APPENDIX G
RETROFIT PLAN FOR MANOR RIDGE APARTMENTS

Manor Ridge Apartments Retrofit Plan – 1

ACCESSIBLE ROUTE DIAGRAM

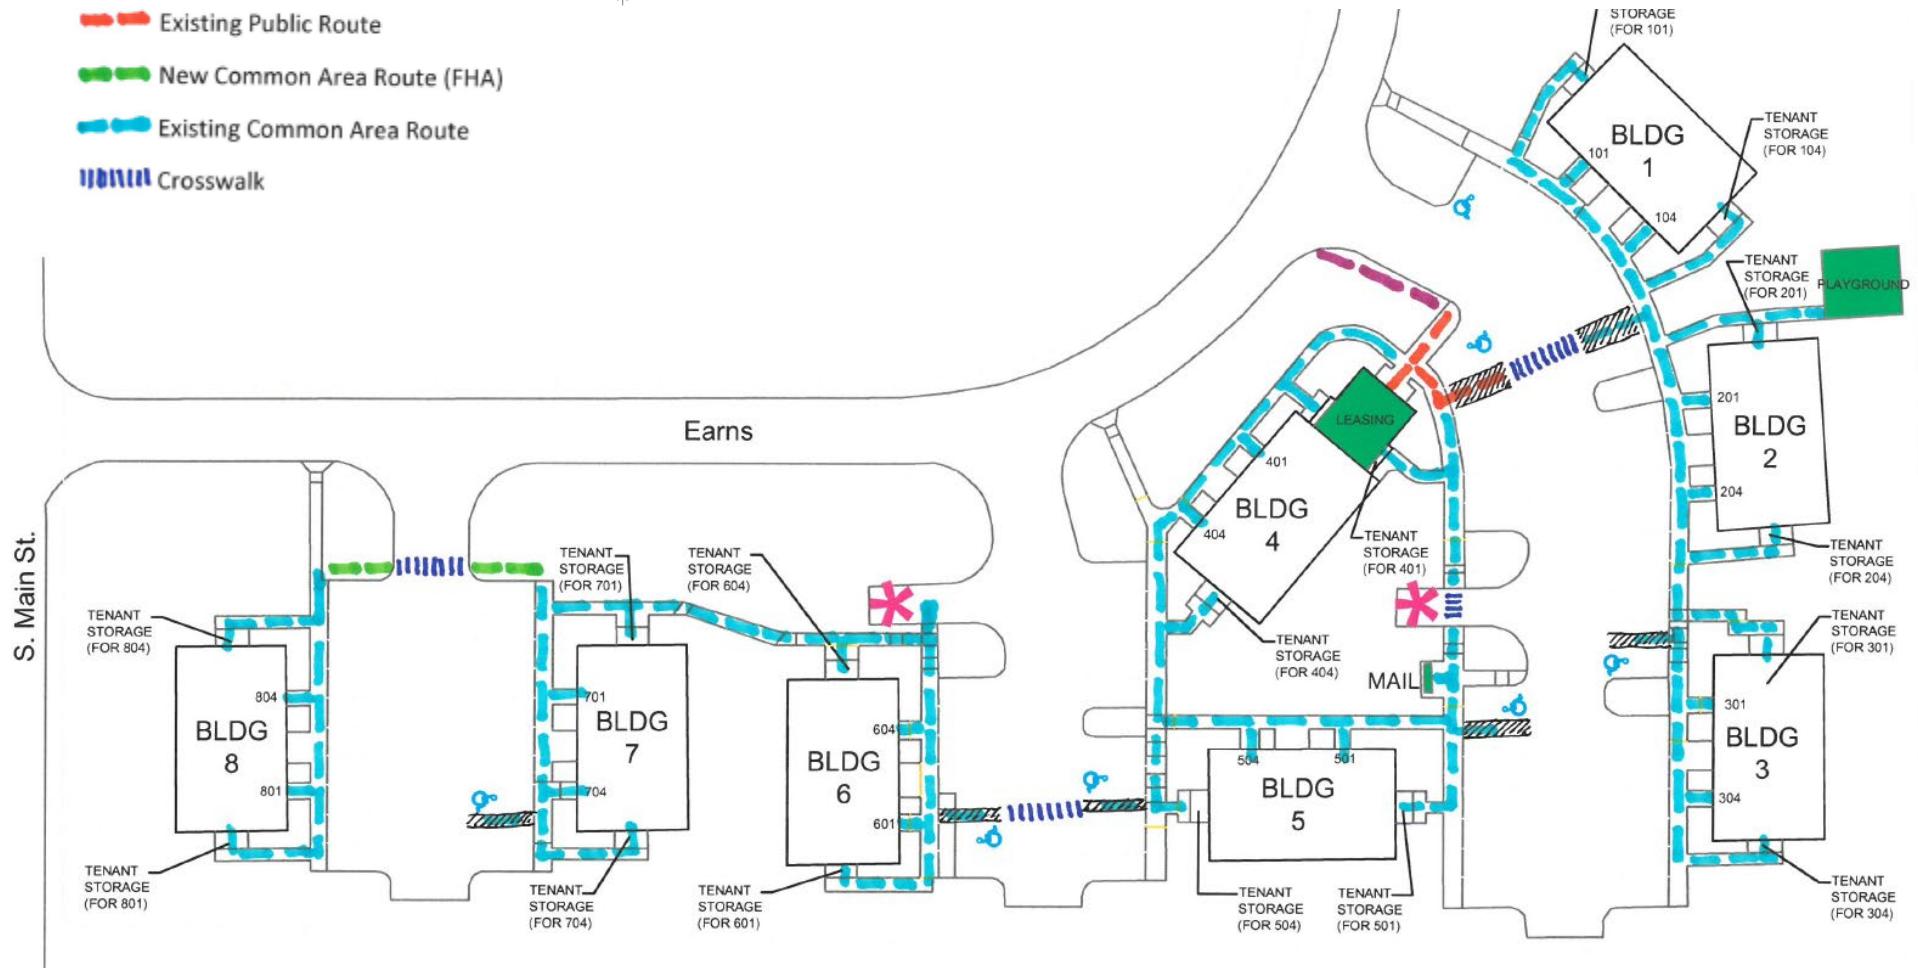
Note: see Accessible Route Diagram for preferred route to Earns Rd.

Lack of Accessible Route			
1	 <p><i>View looking west from north of Building 8.</i></p>	<p>There is no accessible route between pedestrian site arrival points and leasing office; existing route ends at vehicular way (accessible route required).</p>	<p>Provide new sidewalk and curb ramps from Earns Rd. to the existing walk in front of the leasing office building (see Accessible Route Diagram).</p>

Inaccessible Features at Common Use Routes

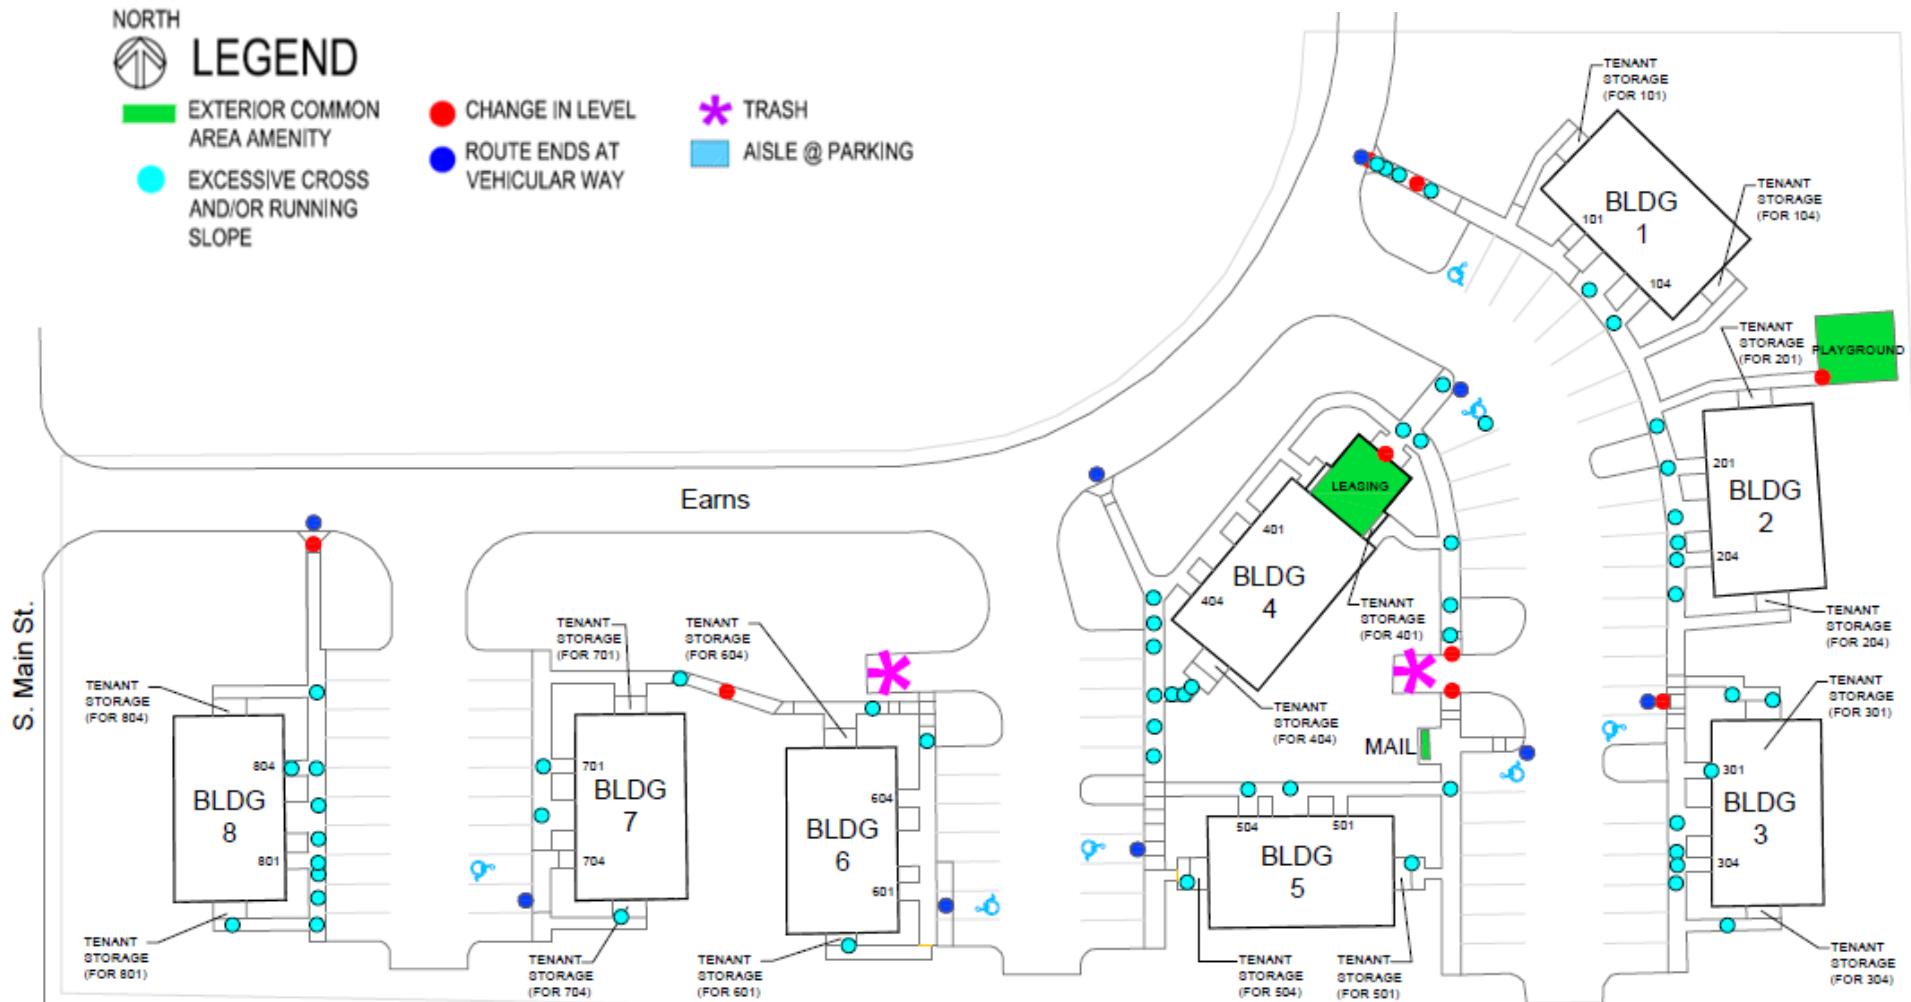
Lack of Accessible Route/Inaccessible Width			
9	<i>See map diagrams.</i>	<p>There is no accessible route from covered dwelling units to common area buildings, site arrival points, leasing office, and exterior common areas and amenities (routes required).</p>	<p>Replace concrete as required to retrofit sections with excessive cross slope. Repave/overlay asphalt at parking spaces and access aisles. Restripe parking spaces and access aisles.</p>
10	 <p><i>Sidewalk south of Building 6.</i></p>	<p>The route south of Building 6 has vegetation overhanging the sidewalk and the clear width is 24 inches (minimum 36 inches required).</p>	<p>Trim vegetation.</p>

Unit Plan. (PENDERGRAPH03205).

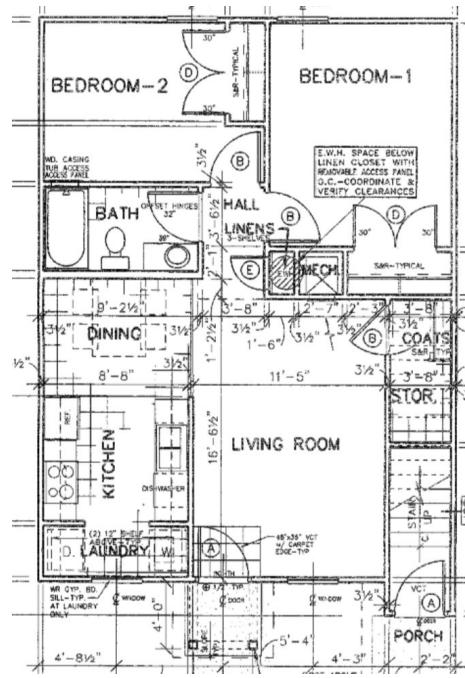
22	 <p><i>Entrance door threshold interior side at Unit 101.</i></p>	<p>Door thresholds are more than 3/4 inches high at the interior face and are not beveled (maximum 3/4 inch with bevel allowed).</p>

23	 <p><i>Clear width of door opening.</i></p>	<p>Bathroom door clear opening widths are 27-5/8 inches (minimum 31-5/8 inch required).</p>	<p>Widen door opening and replace door.</p>
24	 <p><i>Height of outlet in Unit 101</i></p>	<p>Typical outlets are less than 13-3/4 inches to 14 inches above the floor (minimum 15-inches required).</p>	<p>Raise at least one outlet for each room area.</p>

25	 <p><i>Bathtub/shower surround in Unit 101.</i></p>	<p>The shape of the bathtub surrounds precludes the installation of future grab bars with firm attachment to blocking (ability to install grab bars required).</p>	<p>Replace tub surround or install custom grab bars that can be mounted in the required locations at the existing surrounds. If not replacing the tub surround, fabricate at least two custom grab bars for the tub back walls. Maintain a stock of two such grab bars on site at all times. Install on request at no charge.</p>						
26	 <p><i>Dimension from side wall to centerline of lavatory in Unit 101.</i></p>	<p>Lavatory centerlines are less than 24 inches to the side wall (minimum 24 inches required) and the cabinets are not removable. Flooring, base, and finishes do not extend below vanity.</p>

27	 <p><i>Bathroom door leaf in open position at Unit 601</i></p>  <p><i>Dimension from door leaf in open position to bathtub</i></p>	<p>The clear floor space in the bathrooms is 41-3/4 to 42 inches long (minimum 48-inches required).</p>	<p>Reverse the door so that it does not swing into the bathroom.</p>
----	--	---	--

<p>Provide beveled transition strips.</p>	<u>Location</u>	Height (inches)	Unit 101 entrance	1-1/4	Unit 601 entrance	1-3/8
<u>Location</u>	Height (inches)							
Unit 101 entrance	1-1/4							
Unit 601 entrance	1-3/8

Unit Plan. (PENDERGRAPH03205).

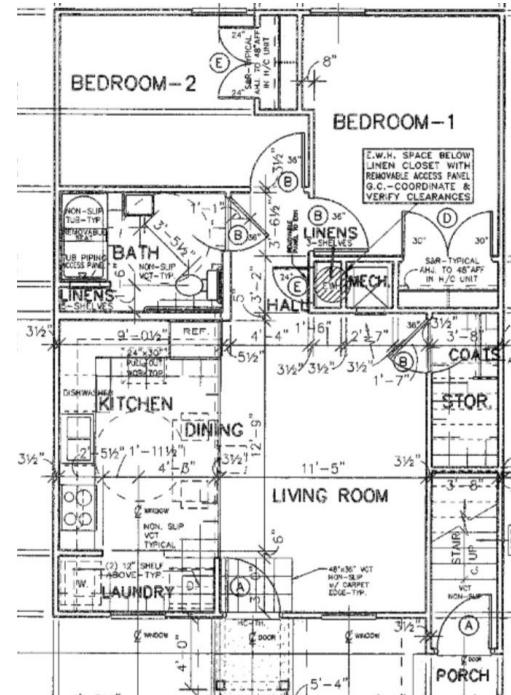
28	 <p><i>Entrance door threshold interior side at Unit 501.</i></p>	<p>Door thresholds are more than 3/4 inches high at the exterior face and are not beveled (maximum 3/4 inch with bevel allowed).</p>

<p><i>Entrance door threshold interior side at Unit 501.</i></p>	<p>“A BEVEL TO ASSIST PERSONS WITH DISABILITIES FOR THIS THRESHOLD IS AVAILABLE UPON REQUEST. CONTACT MANAGEMENT.”</p>
29	 <p><i>Linen storage in unit 501.</i></p>  <p><i>Measurement of clear opening.</i></p>	<p>The width of the clear opening at the linen closet doorway is 15-1/8 inches and the closet depth is 36 inches (minimum 31-5/8 inch clear opening width required).</p> <p>(Note: shelf is mounted on the long sidewall of the closet space.)</p> <p>Widen door or install new back wall at closet such that closet depth is reduced to 24 inches.</p>

<p><i>Measurement of depth.</i></p>		
30	 <p><i>Height of outlet in Unit 501</i></p>	<p>Typical outlets are 13-5/8 inches above the floor (minimum 15 inches required).</p>	<p>Raise at least one outlet for each room area.</p>

<u>Location</u>	Height (inches)	Unit 501 entrance	1-1/4	Unit 501 storage (storage closet is more than 24 inches deep)	1-1/4	<p>At unit entry doors: Provide beveled transition strips.</p> <p>At unit storage closet doors: Provide beveled transition strip or offer remediation upon request of tenants. If offered on tenant request, a durable-material placard, contrasting black text on white background, in minimum 14-point font, must be placed on the side of the patio door stating:</p>
<u>Location</u>	Height (inches)								
Unit 501 entrance	1-1/4								
Unit 501 storage (storage closet is more than 24 inches deep)	1-1/4

Unit Plan. (PENDERGRAPH03205).

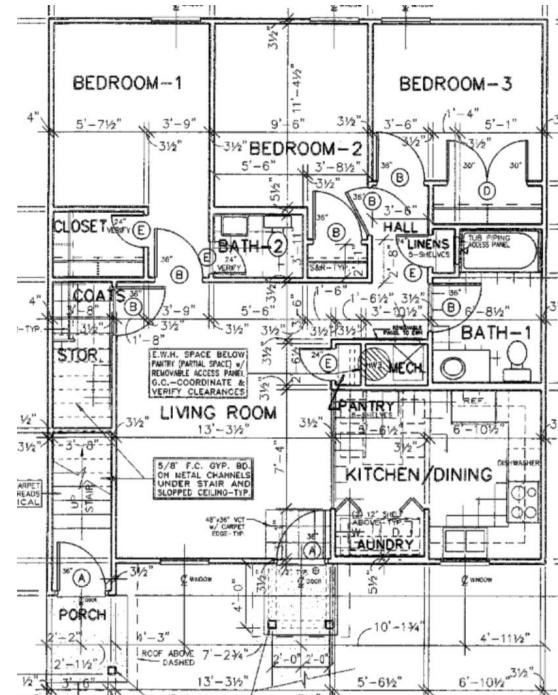
31		Door thresholds are 1-3/8 inches to 1-1/2 inches high at the interior face and are not beveled (maximum 3/4 inch with bevel allowed). <i>Entrance door threshold interior side at Unit 304.</i>	Provide beveled transition strips.
----	--	--	------------------------------------

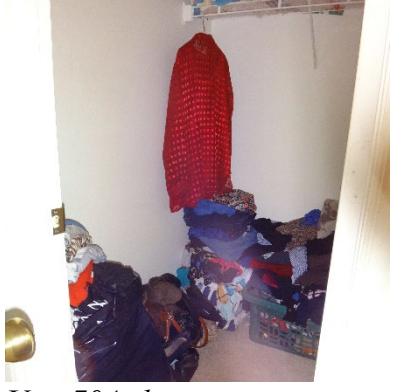
32	 <i>Measurement of door width at Unit 704 walk-in closet.</i>  <i>Unit 704 closet.</i>	<p>Door clear opening widths are less than 31-5/8 inches (minimum 31-5/8 inch required).</p>

<u>Location</u>	<u>Clear Width (inches)</u>	Unit 304, walk-in closet	21-3/4	Unit 304, powder room	22	Unit 704, walk-in closet	22	Unit 704, powder room	22	<p>Widen door to provide a compliant clear opening width or install new back wall to closet that reduces the closet depth to 24" interior depth.</p>
<u>Location</u>	<u>Clear Width (inches)</u>												
Unit 304, walk-in closet	21-3/4												
Unit 304, powder room	22												
Unit 704, walk-in closet	22												
Unit 704, powder room	22												
33	 <i>Height of outlet in Unit 304.</i>	<p>Typical outlets are 14 inches above the floor (minimum 15 inches required).</p>	<p>Raise at least one outlet for each room area.</p>
